FINAL DRAINAGE REPORT FOR ZINDORF — MCDANIEL'S SUBDIVISION

June 2022

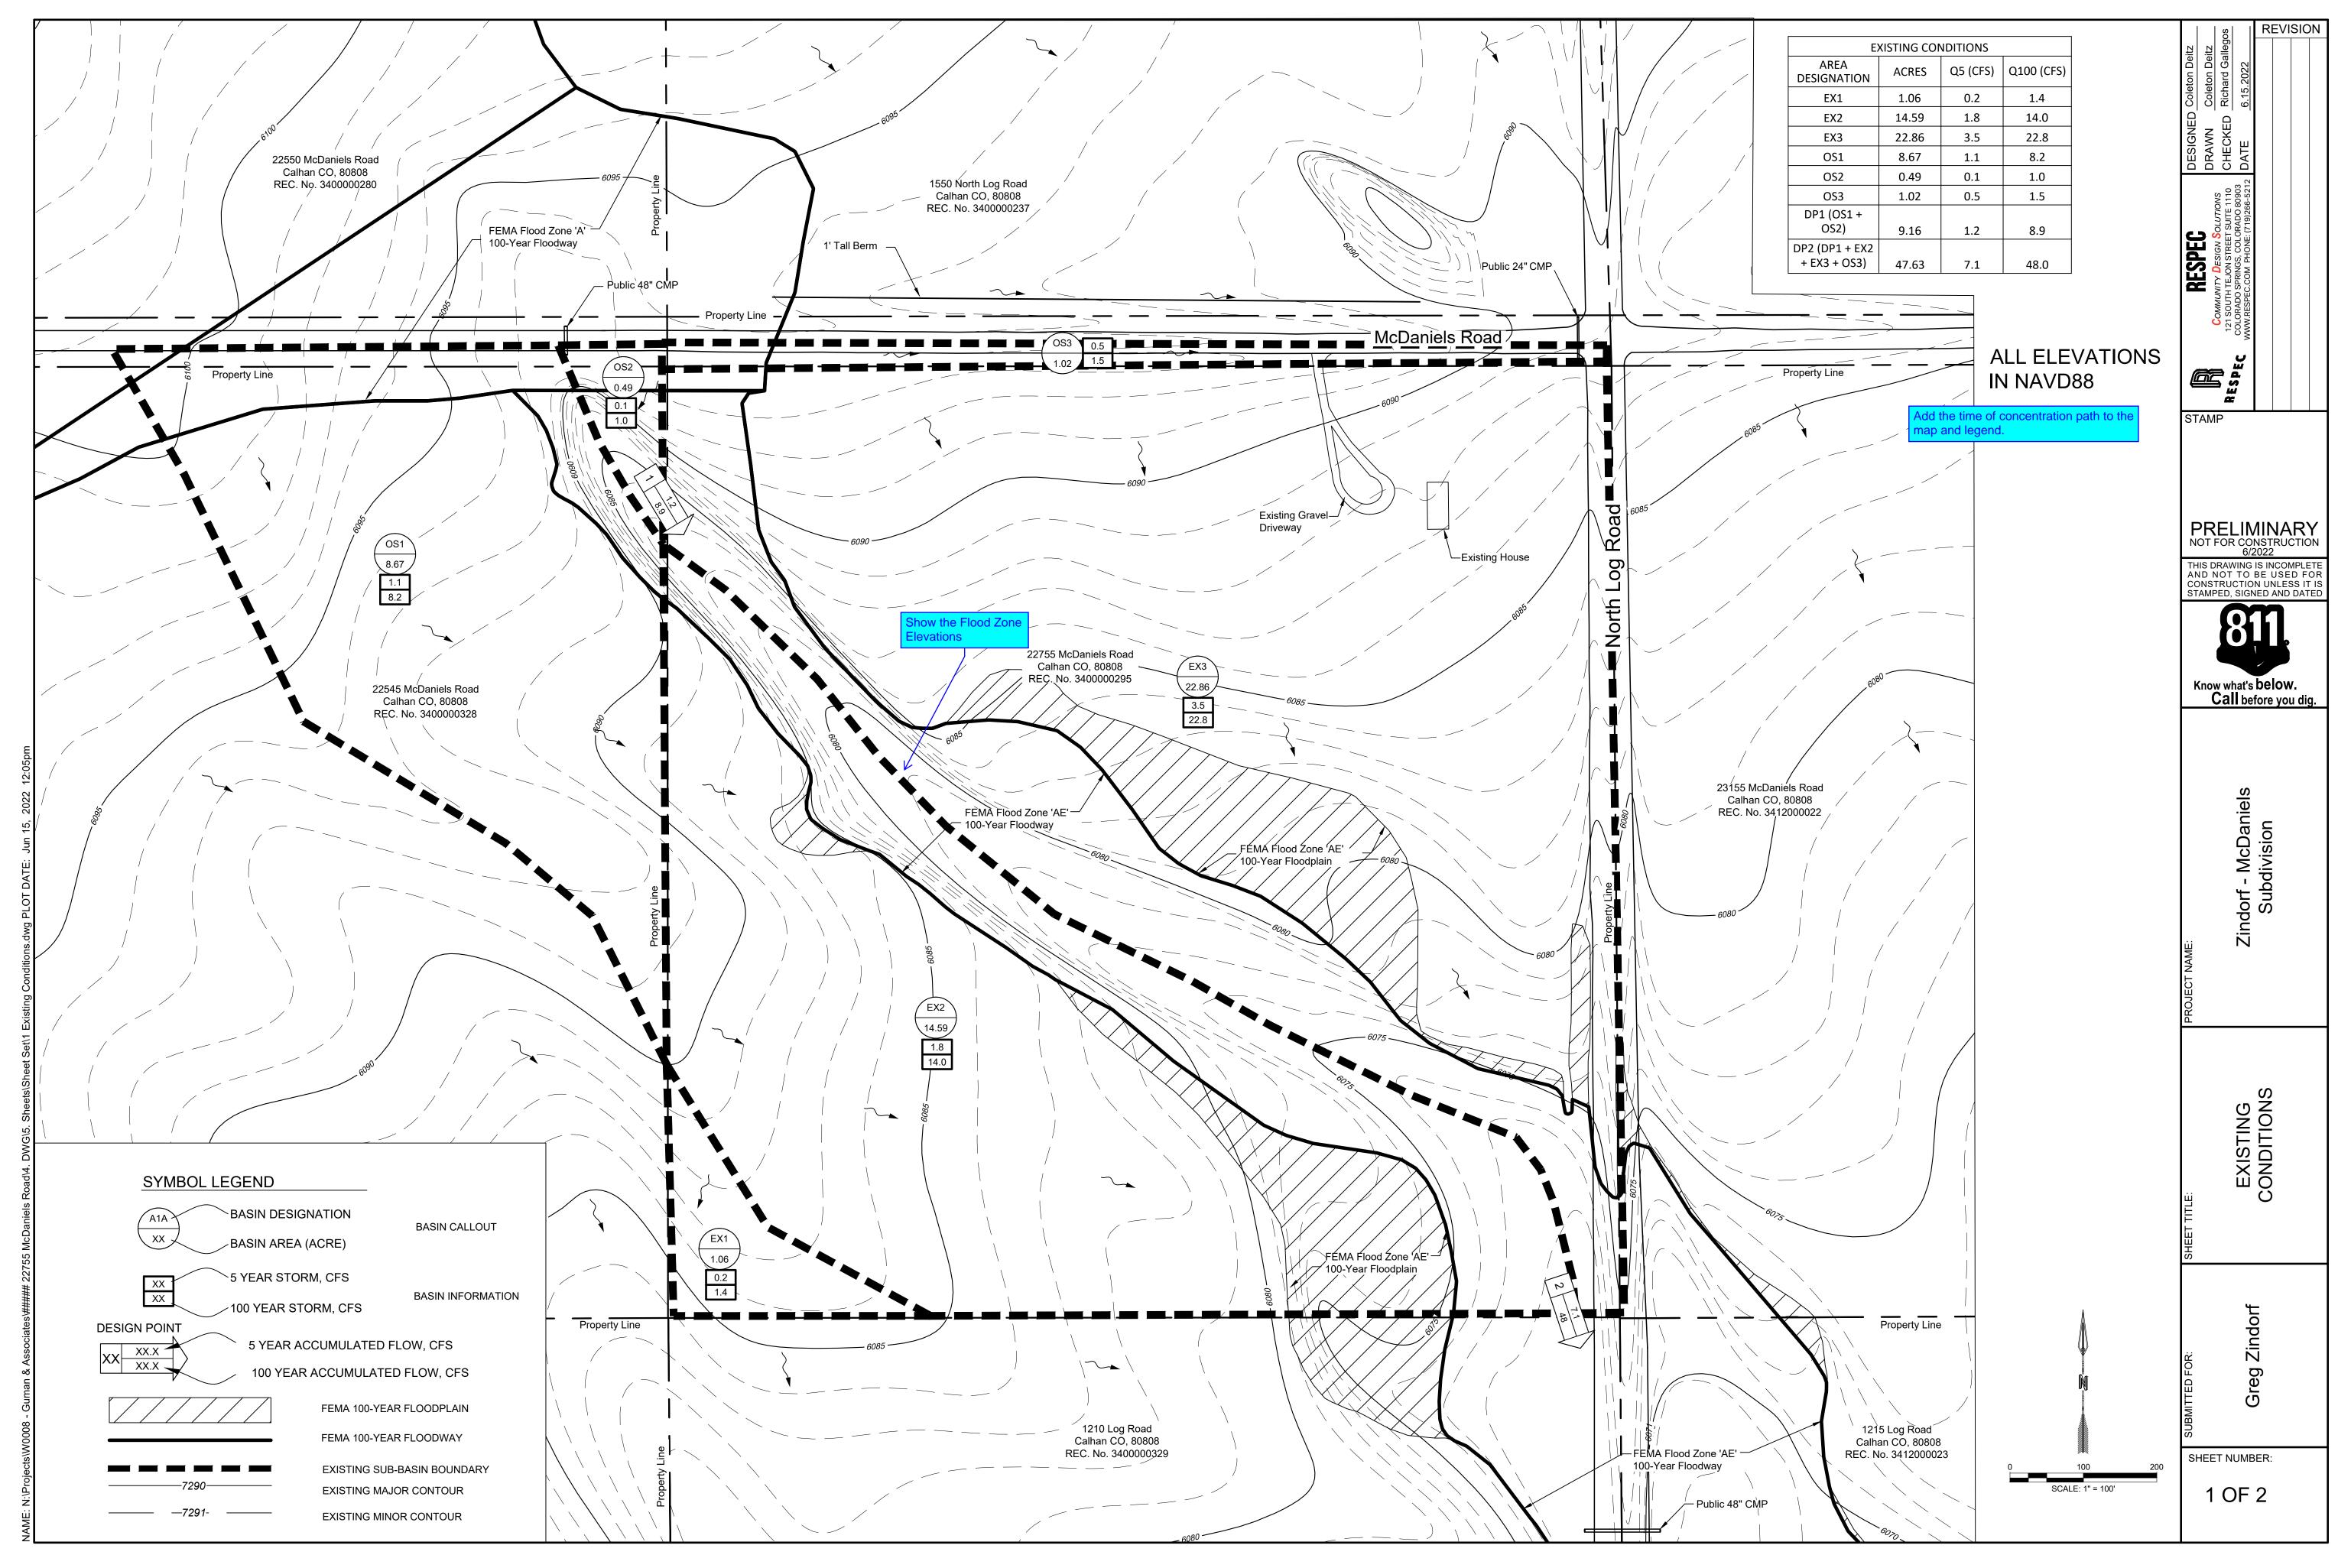
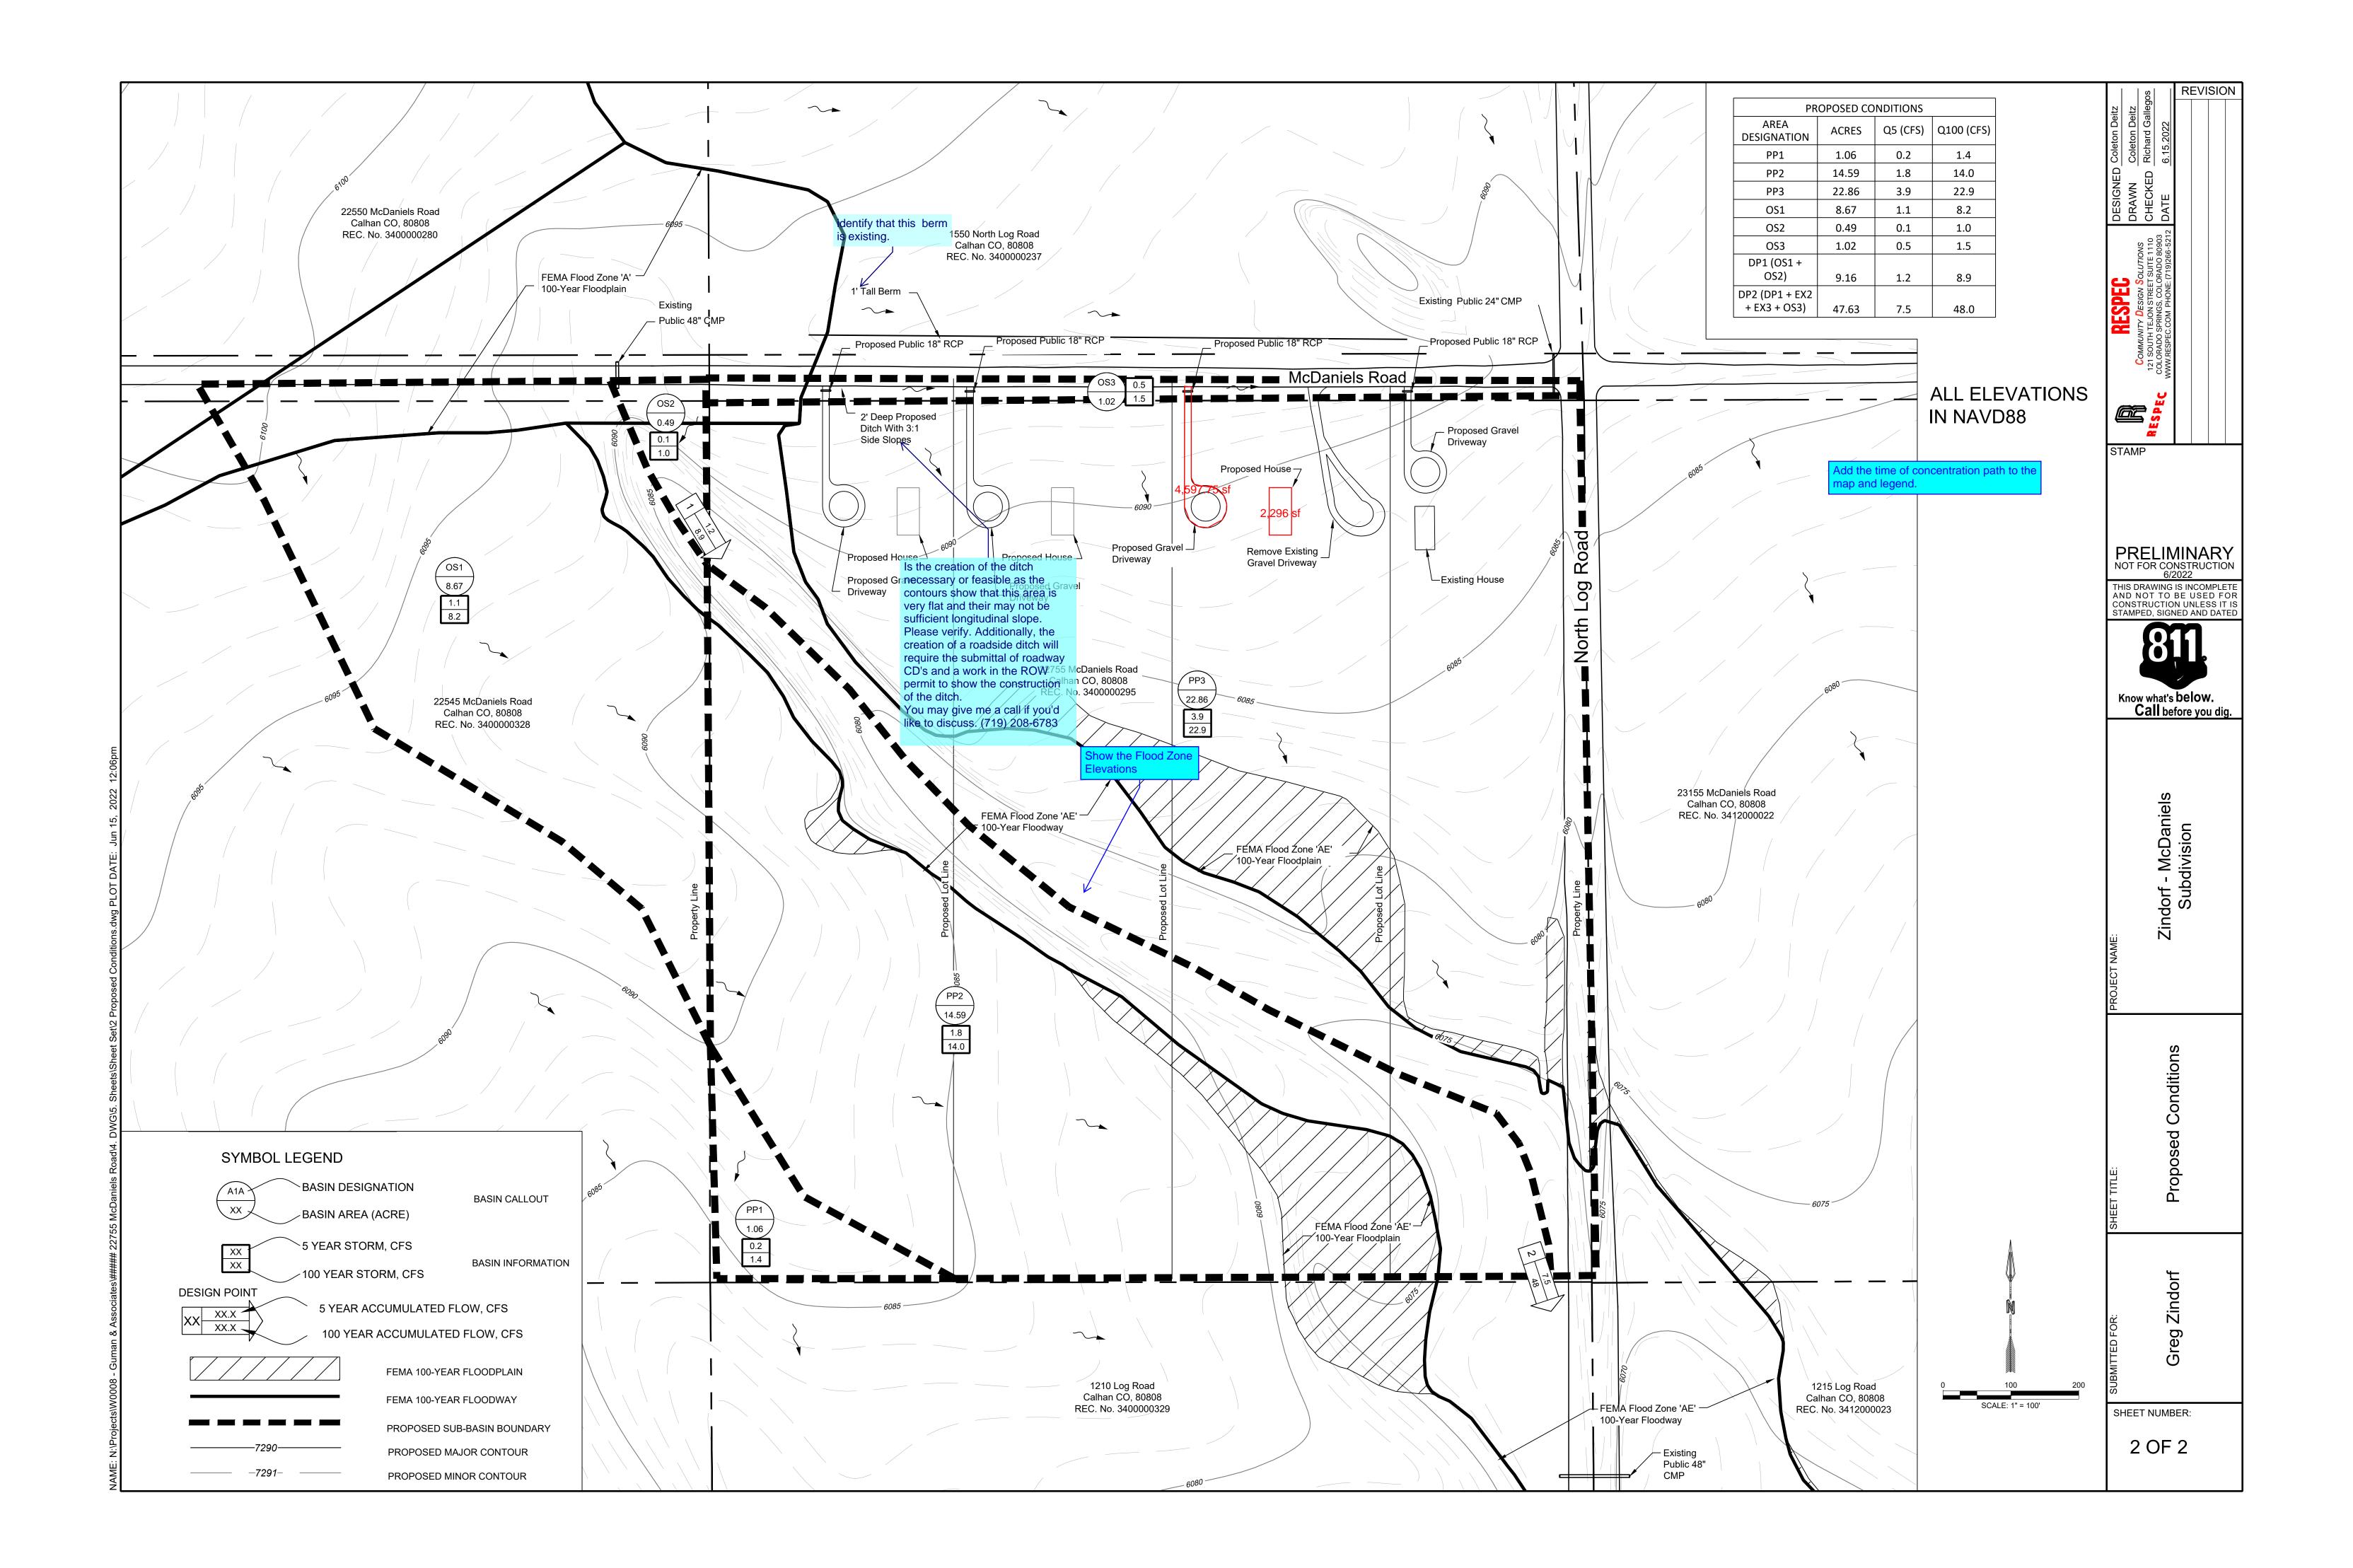
Please add "PCD File No. MS-22-006" to the botton right hand corner of both drainage maps.
